Gulf GSRC Co., Ltd.

Executive Summary on EIA Addendum Report
to Environmental Impact Assessment Report of
SRIRACHA Power Plant Project
(No.3)

March 2025

Prepare by
TLT Consultant Co., Ltd.

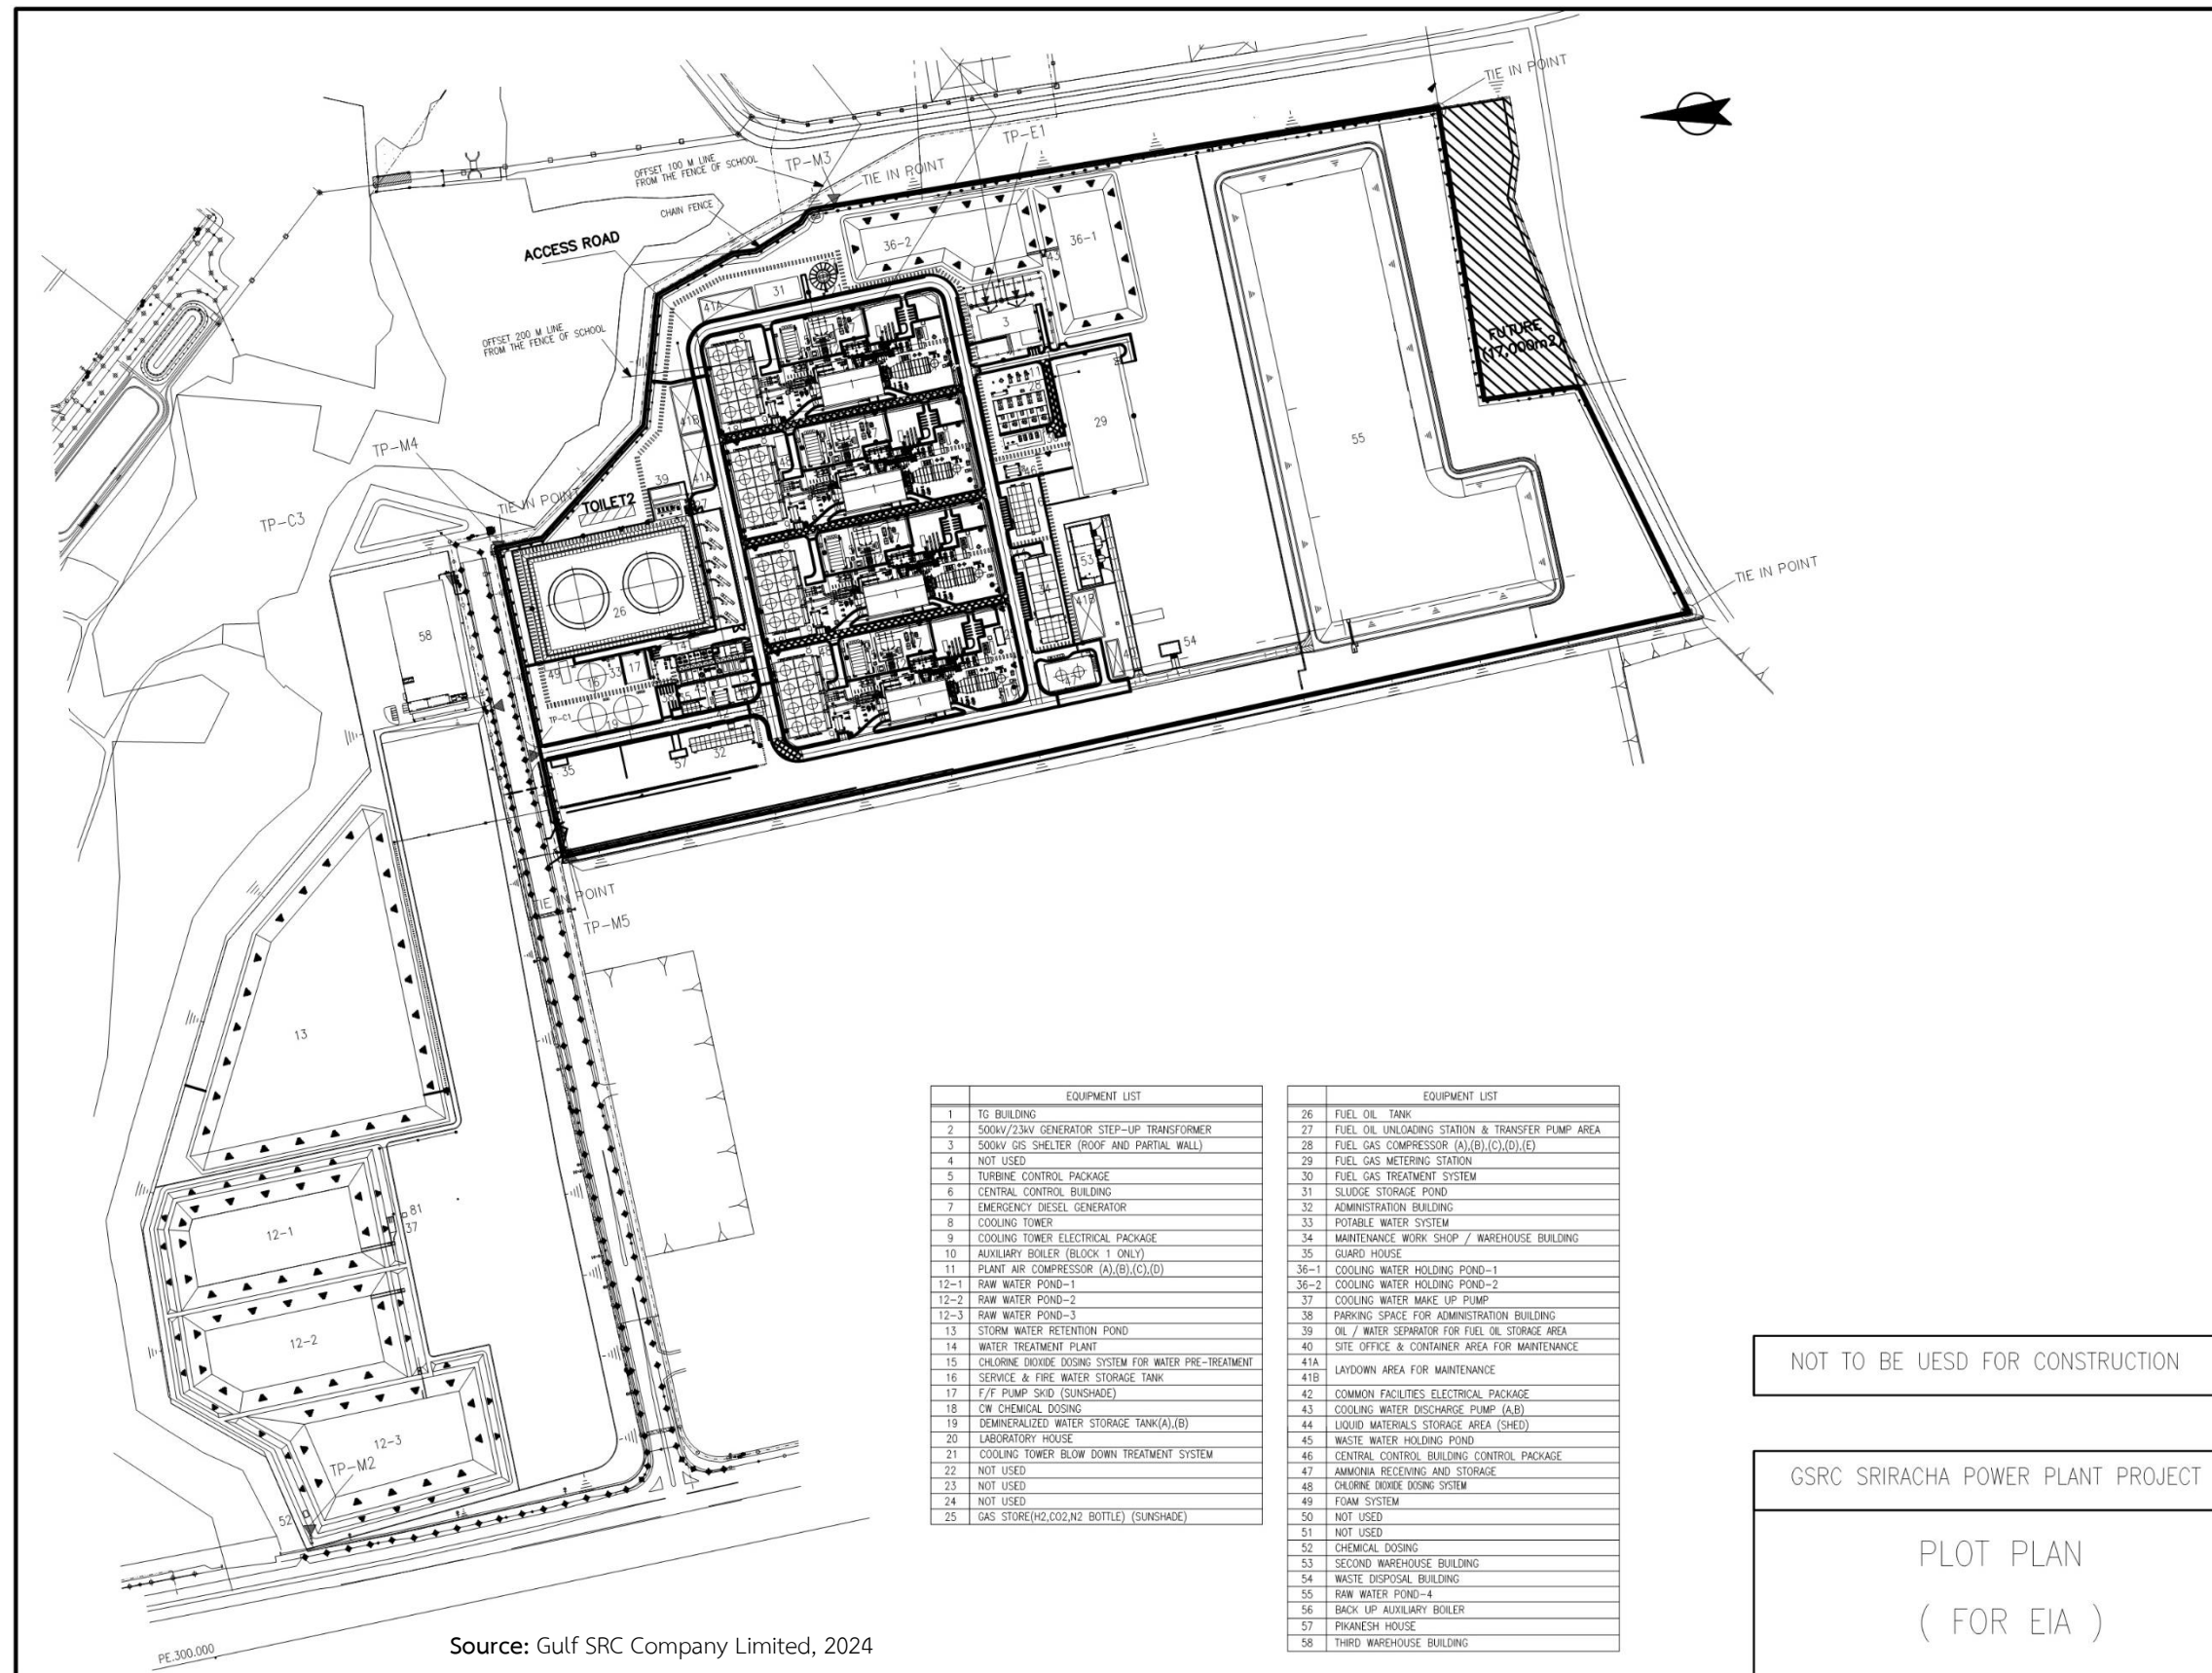
- The addition of a Third Warehouse Building, covering 5,940 square meters, resulting in an increase of 5,940 square meters in land usage for building-up areas (as shown in **Figures 2-1 and 2-2**).

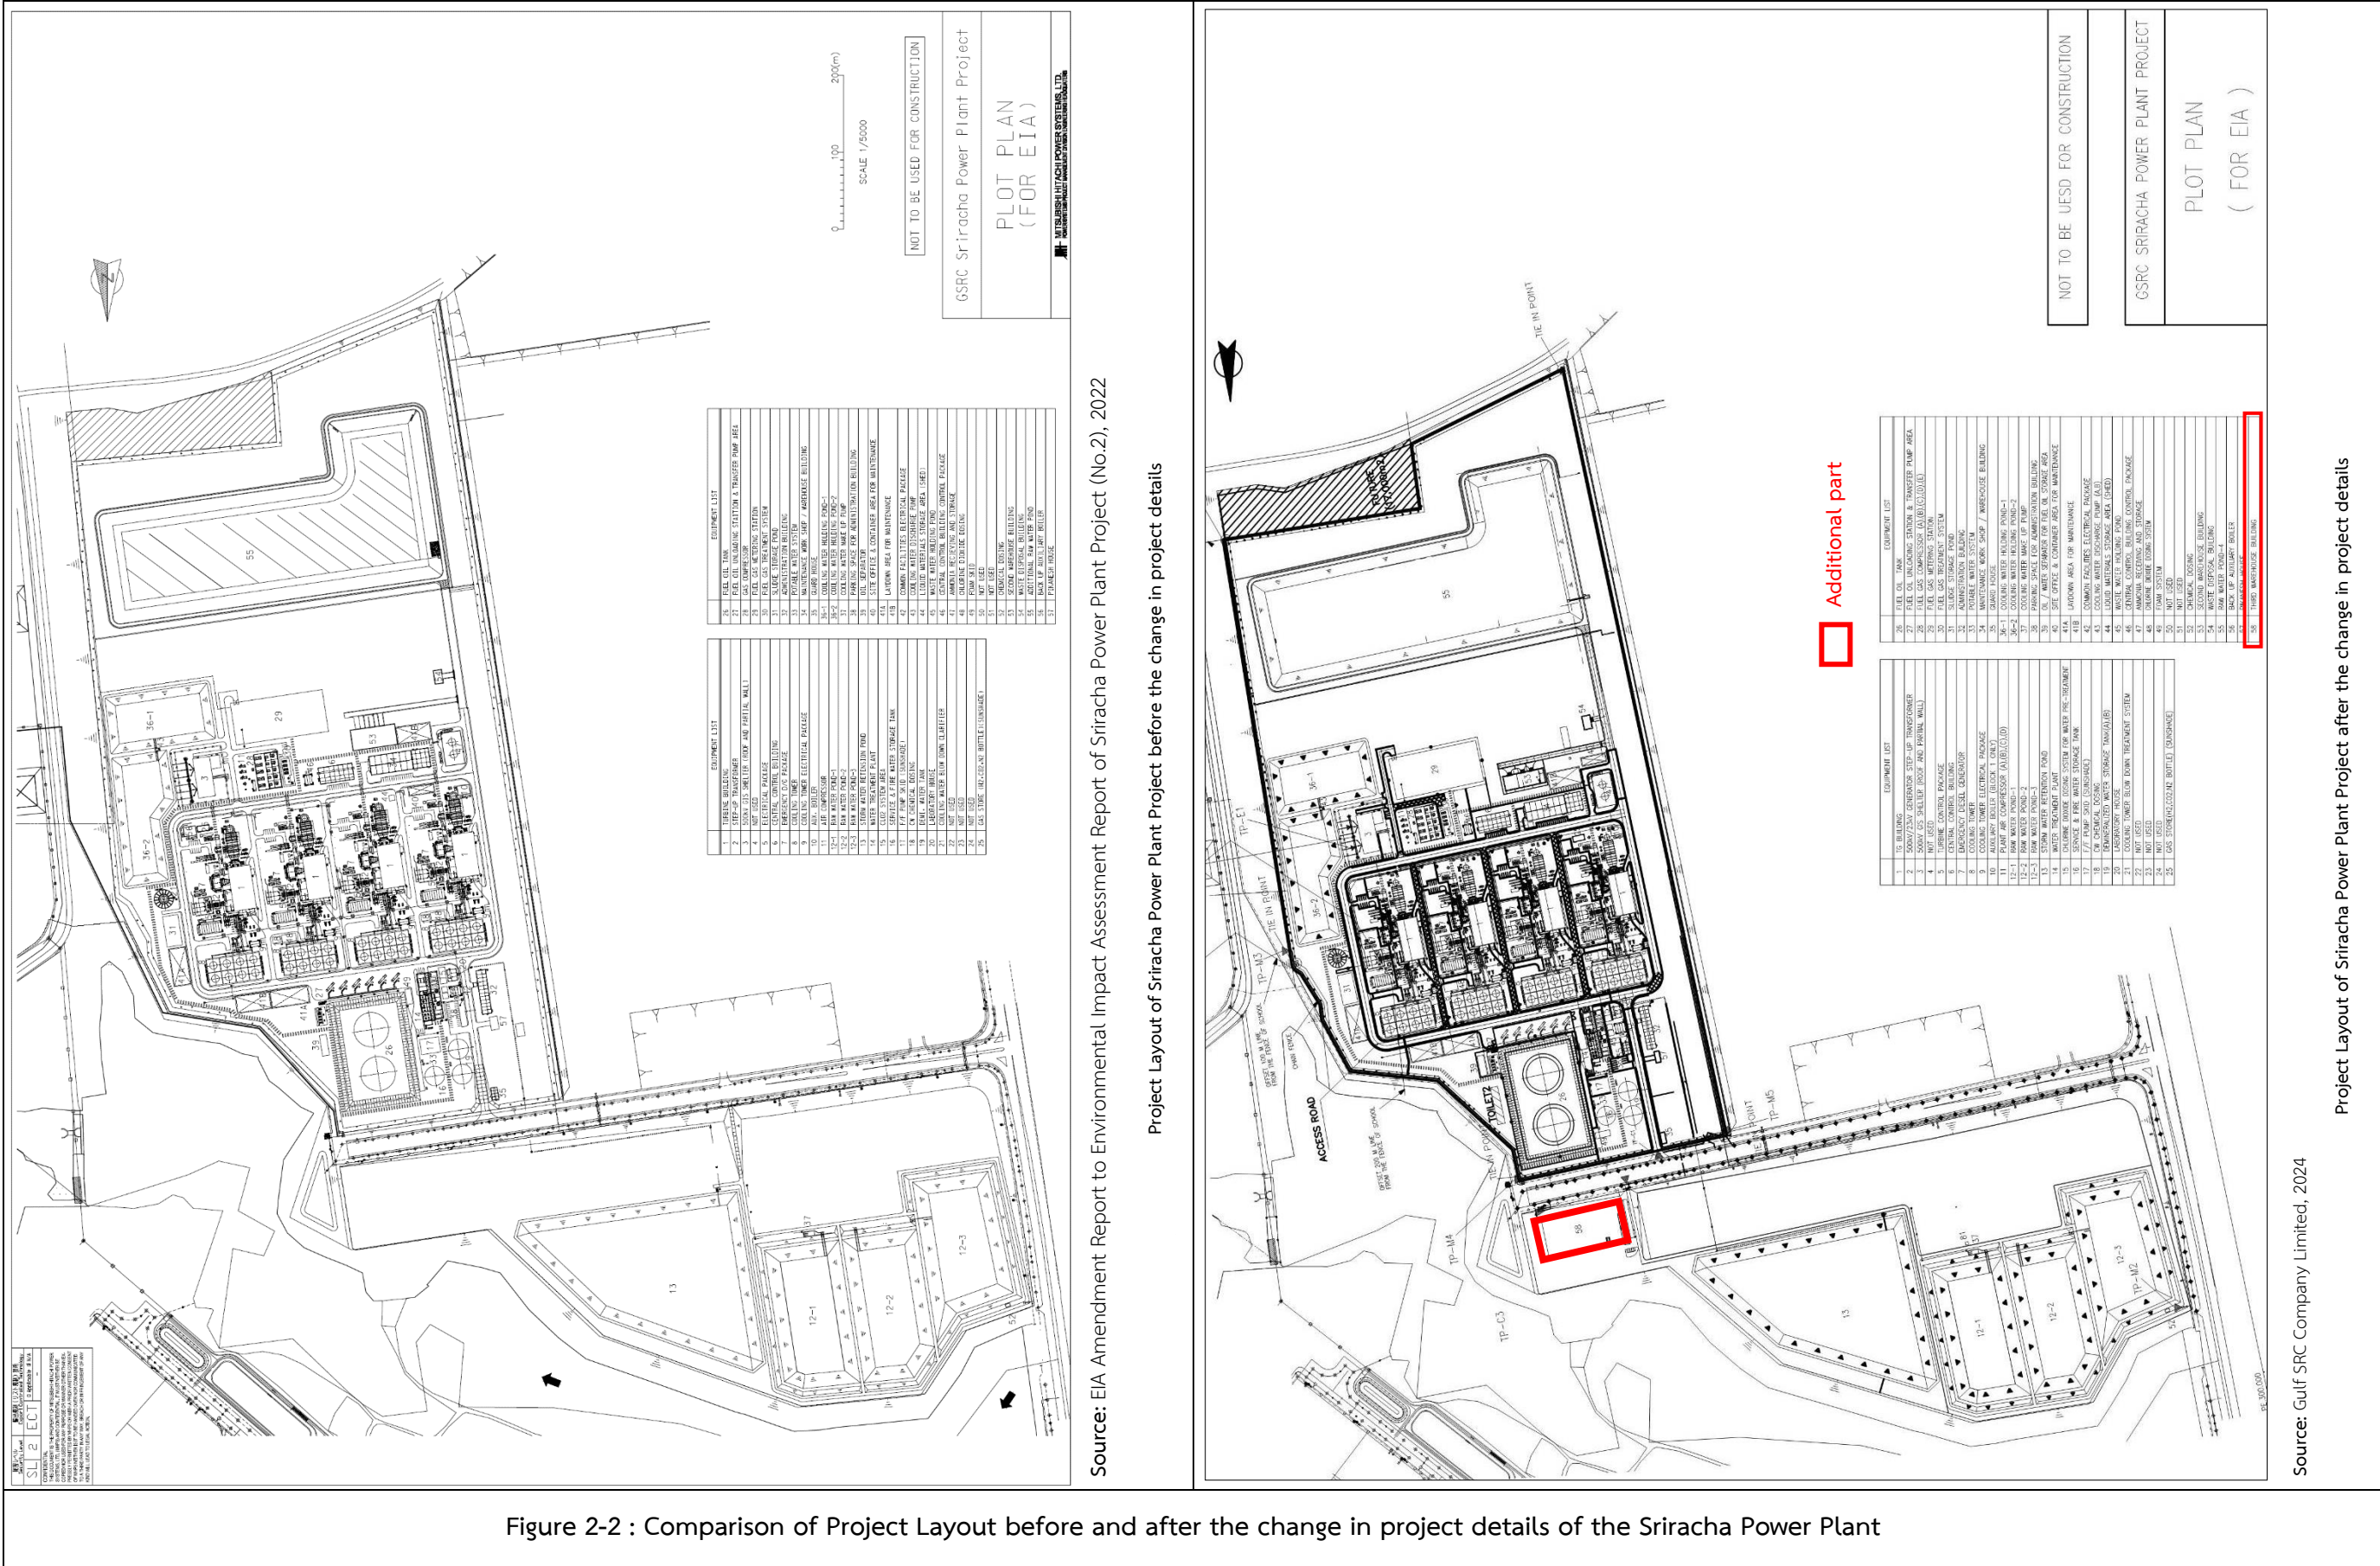
After the changes in the project details, the area reserved for future development is reduced by 5,940 square meters. However, the total green area within the project area remains the same at 35,300 square meters. The proportions of the project area that is being utilized is shown in **Table 2-1**.
